CHANGE ORDER NUMBER: 1

Project: 1809-261

Roadway: CR 110 Middle

Change Order No. 1

132

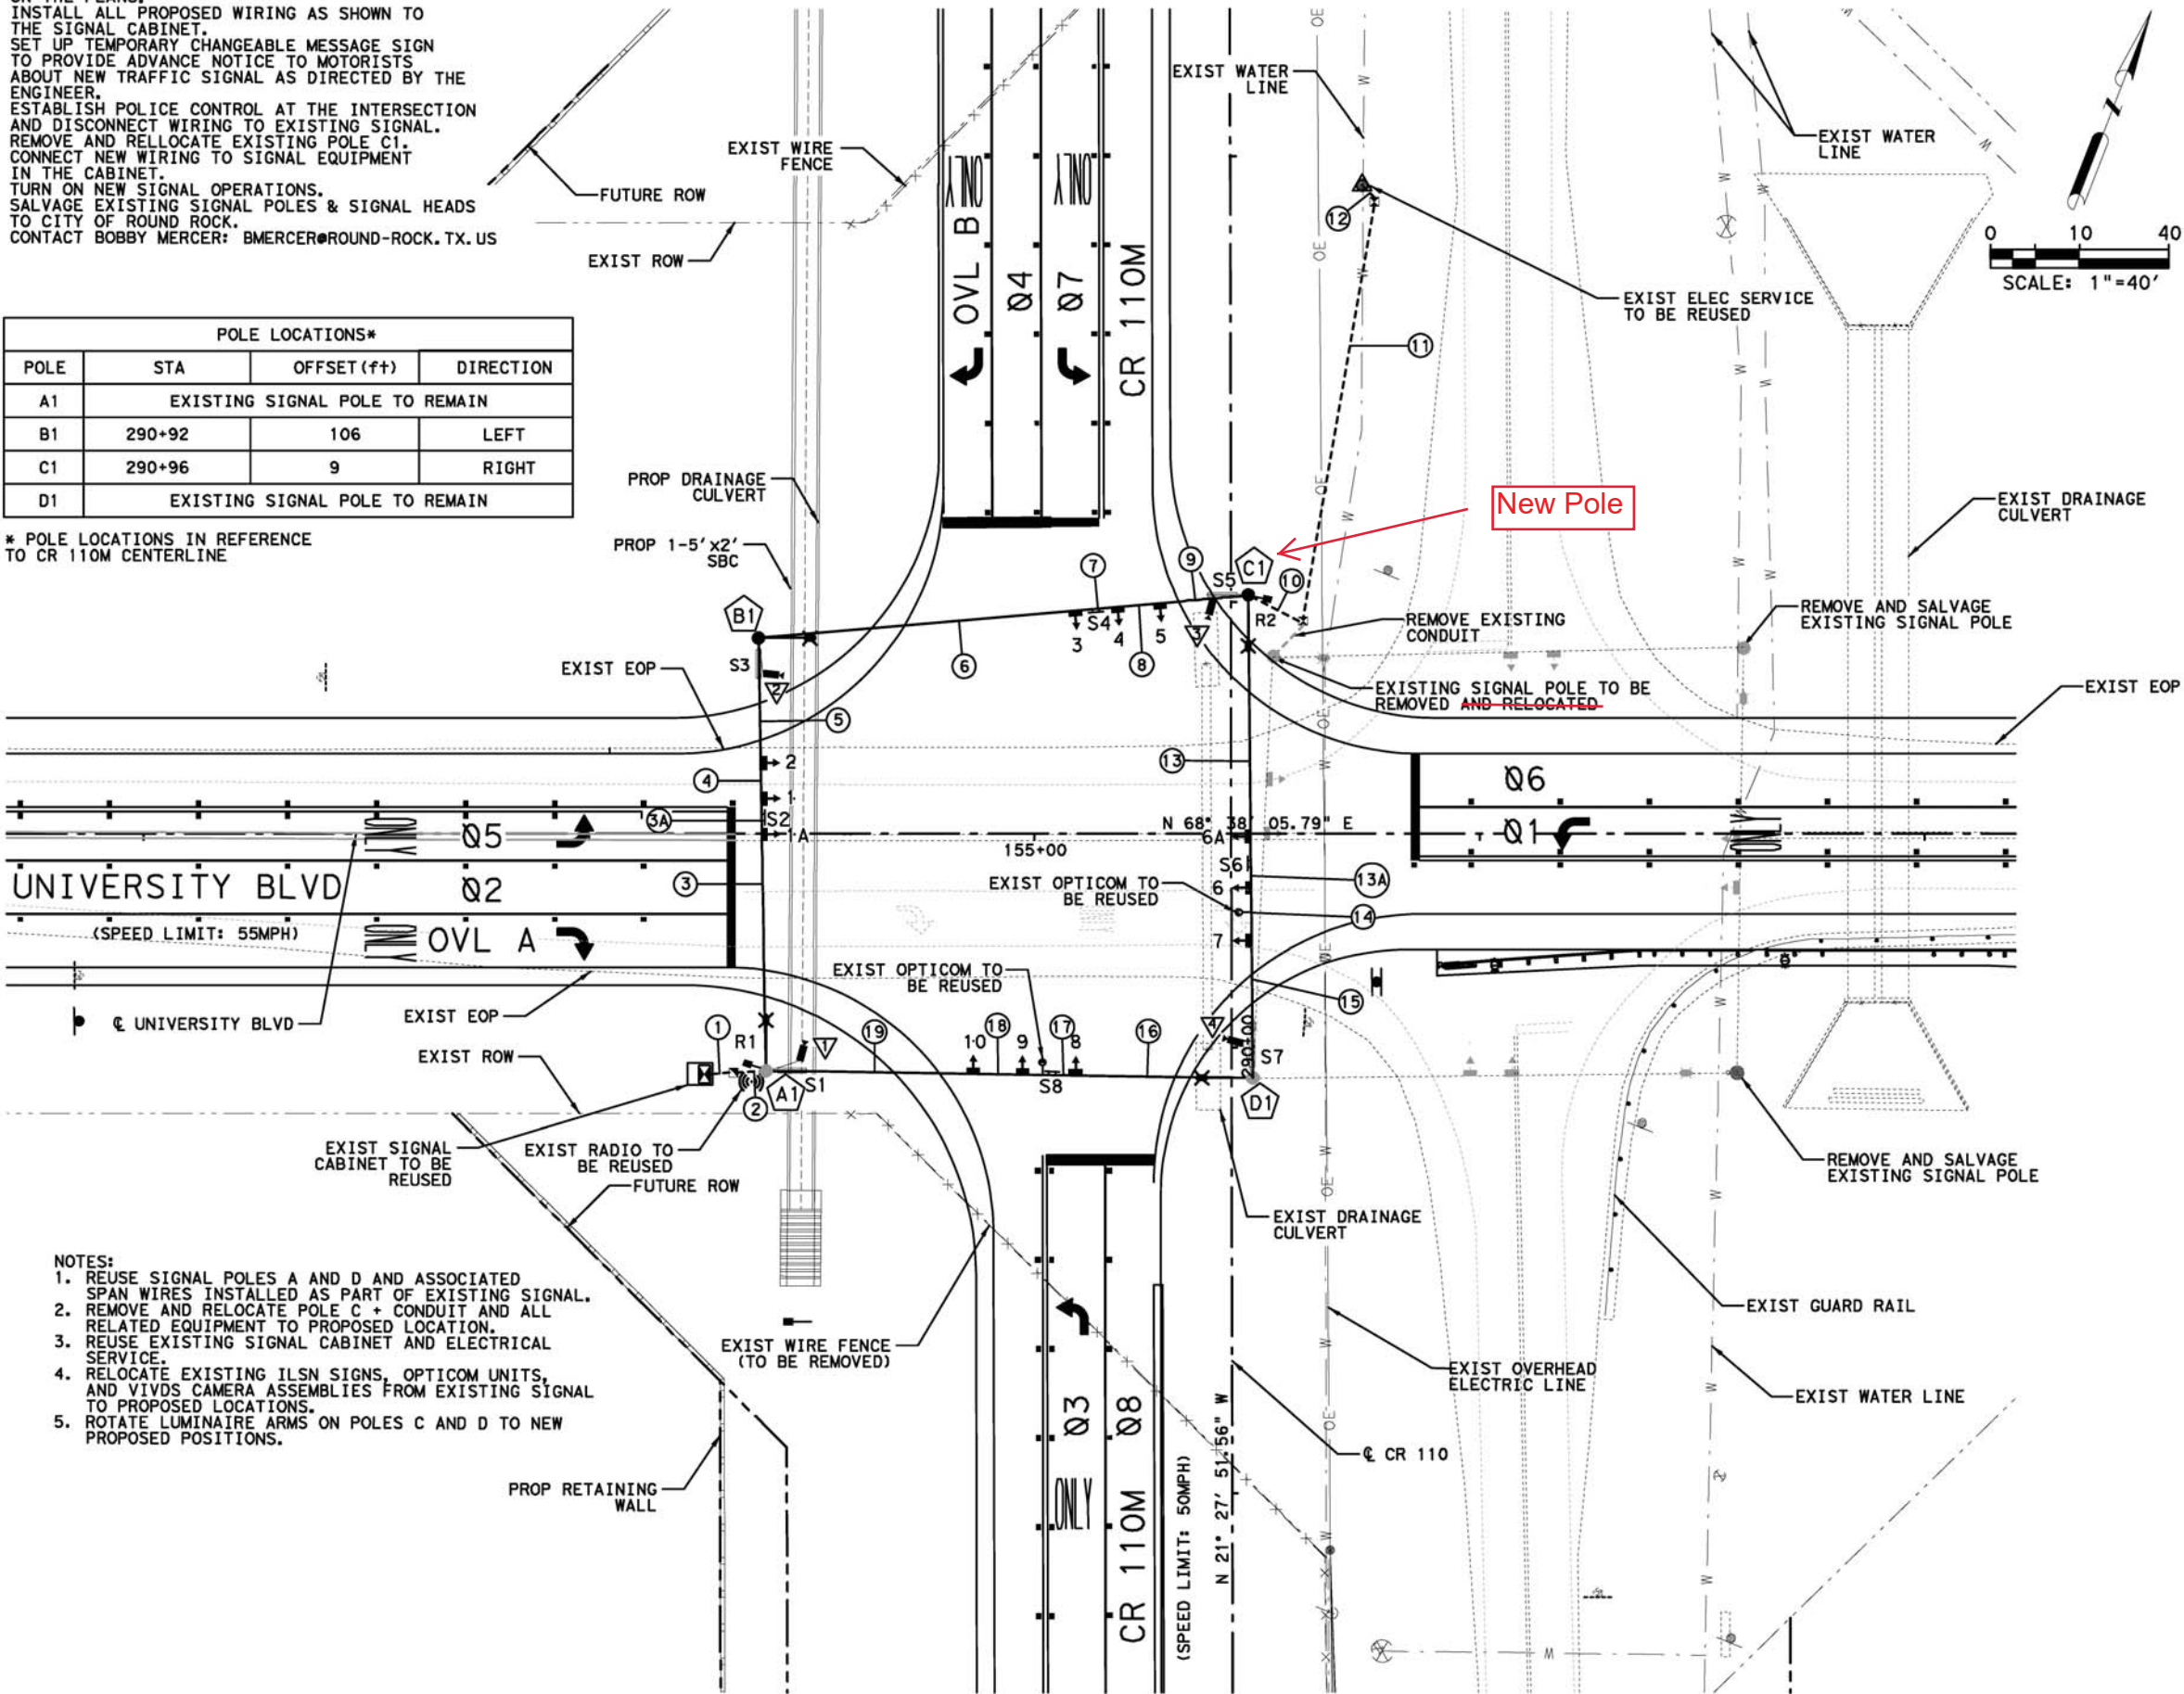
Type D signal poles replaces the Type B signal poles originally called out in the plans. The Type B poles are not sufficient for the length of the mast arm. The Type D poles require deeper drill shaft foundations, adding quantity to the drill shafts. Additionally, street name signs will be added to the signals at Limmer Loop.

△ ADJUSTED SIGNAL FOUNDATION QTY

137B

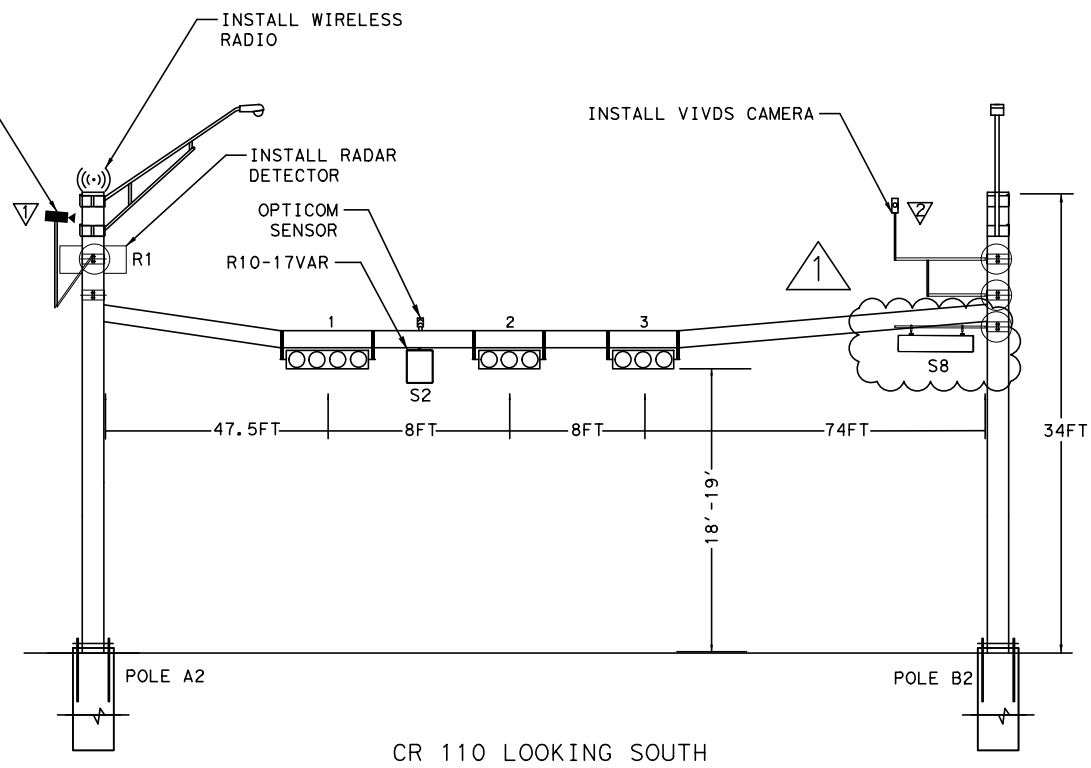
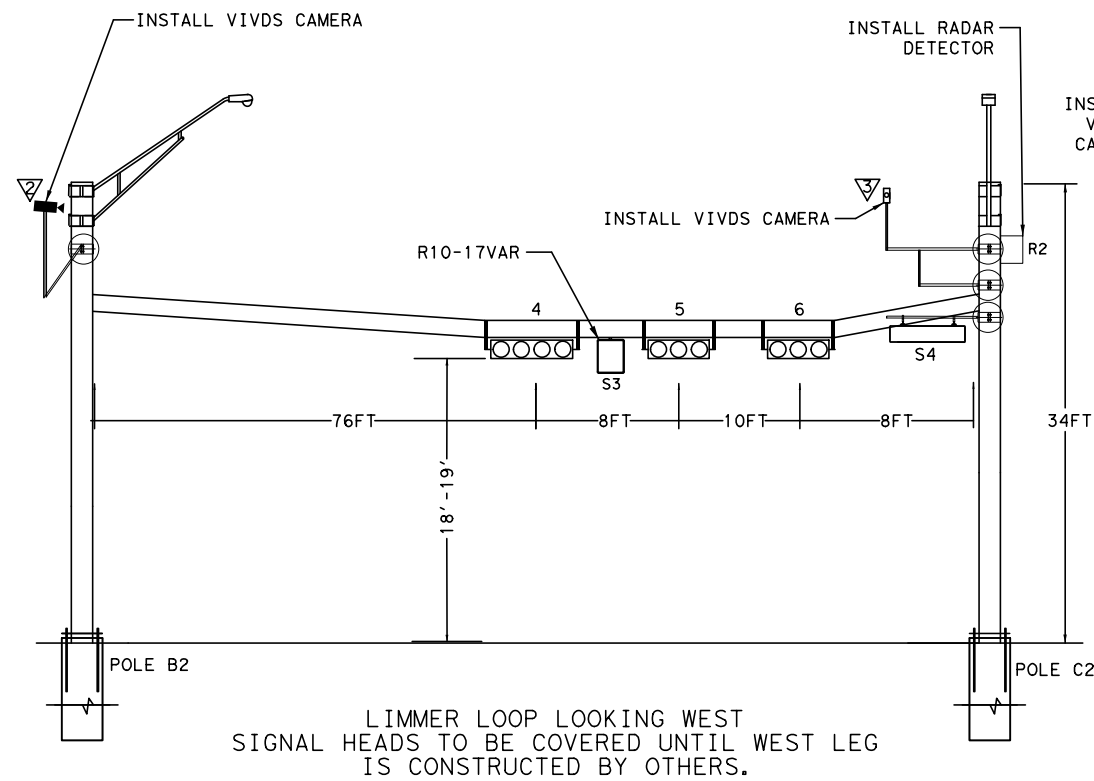
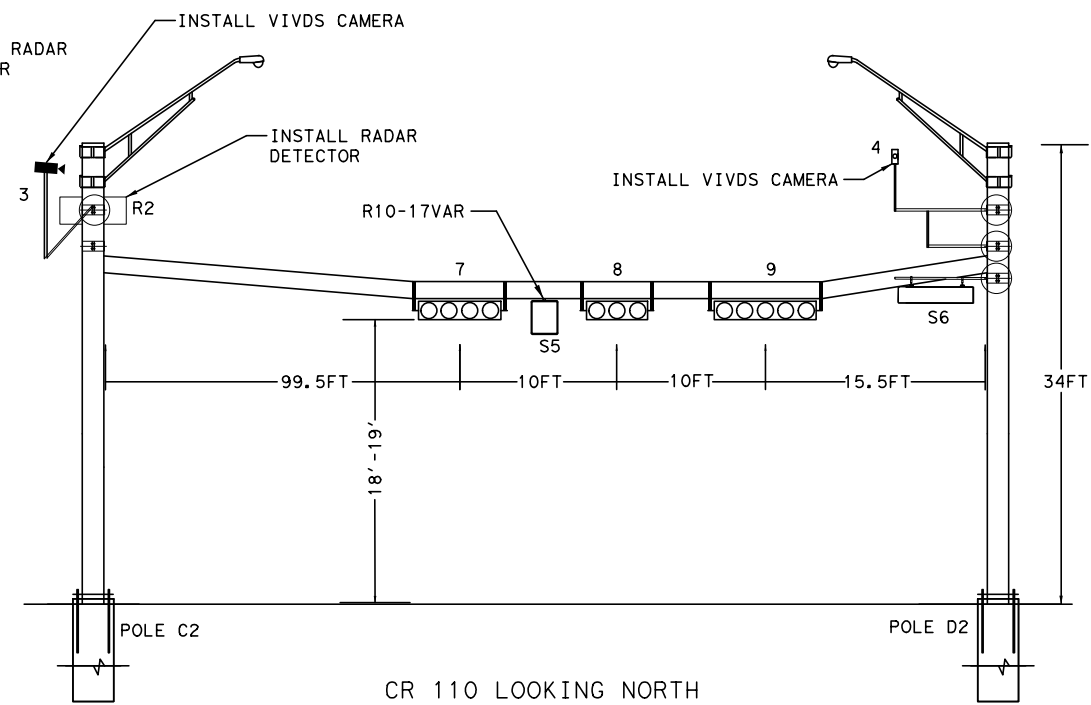
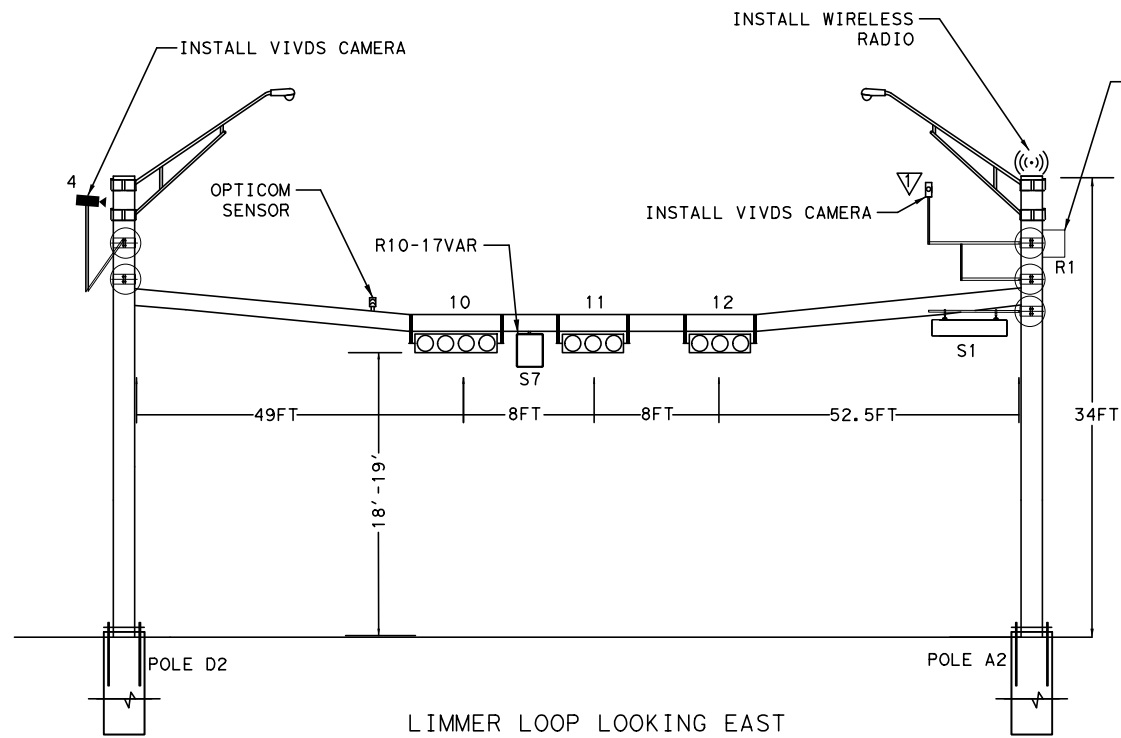
1 ADDITIONAL ILSN

137C

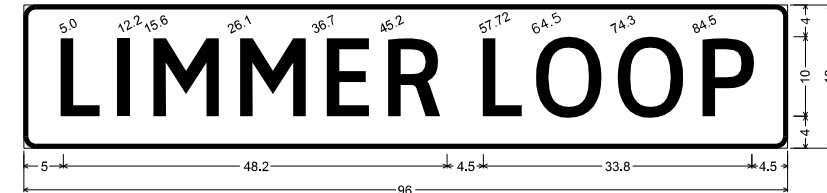
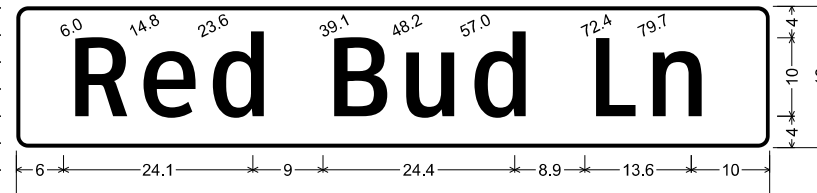
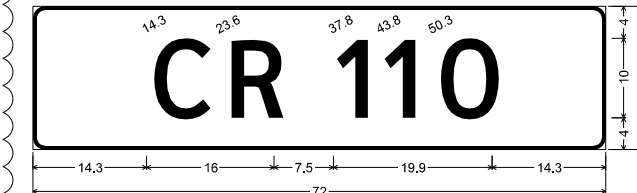
1 ADDITIONAL ILSN

137E

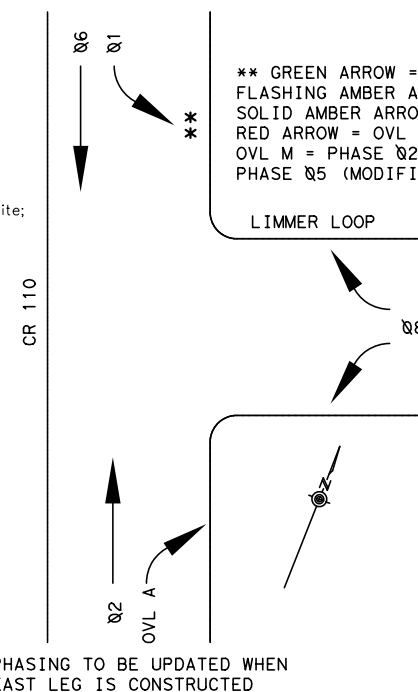
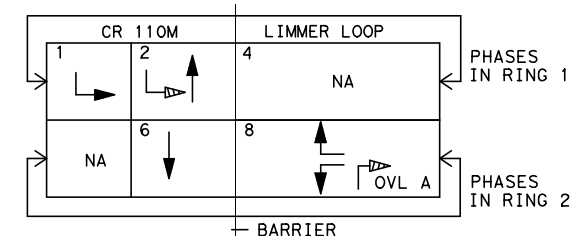
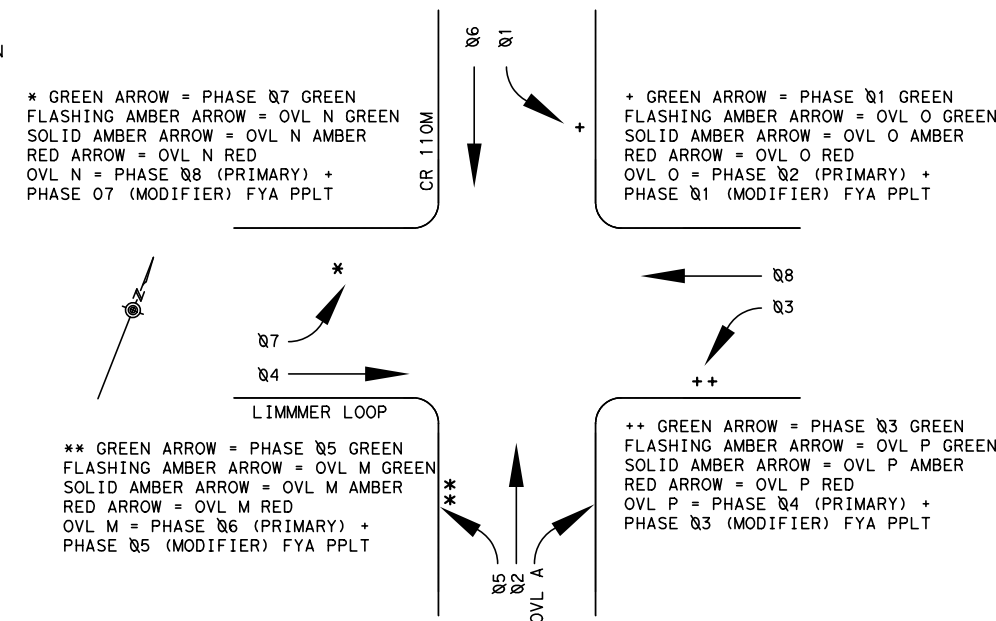
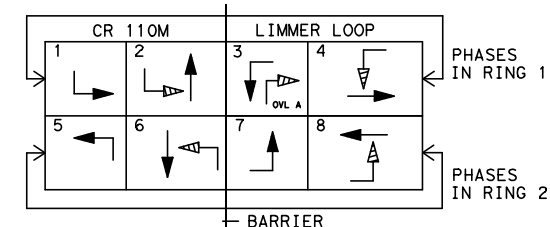
ADDITIONAL ILSN

TS-FD-12

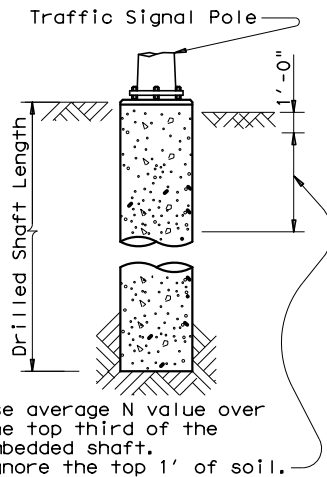
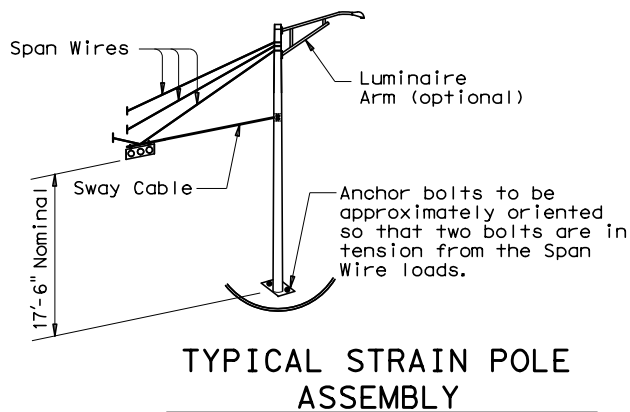
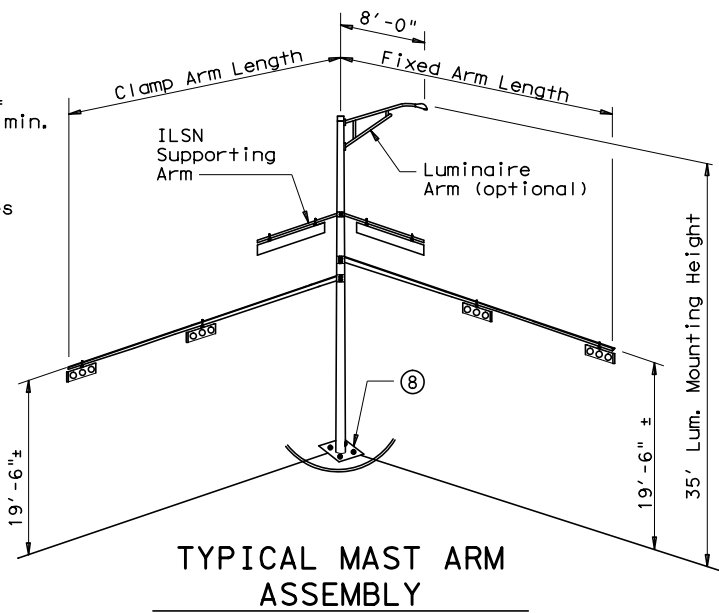
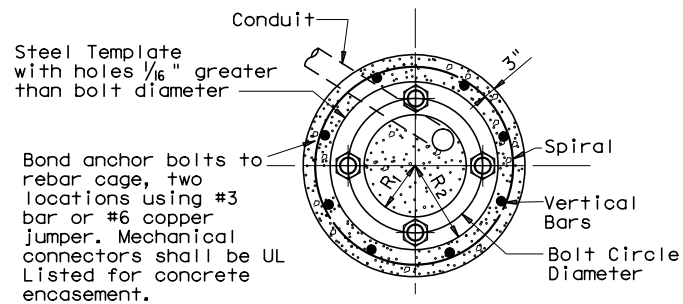
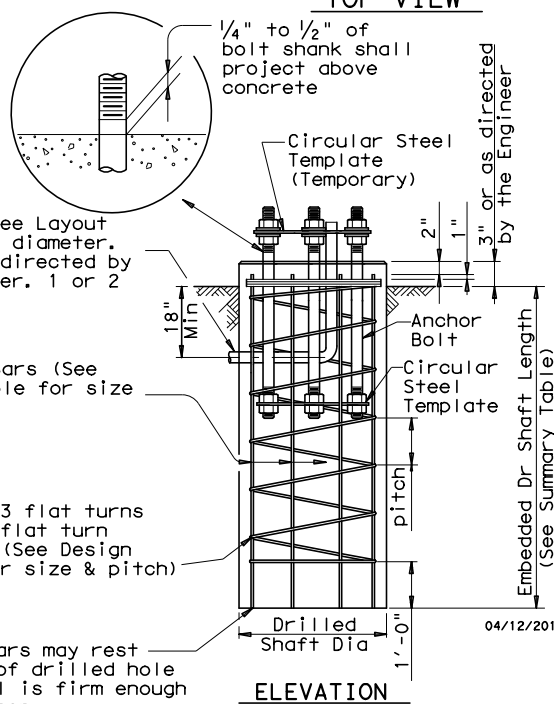
△ ADJUSTED SIGNAL
FOUNDATION QTY
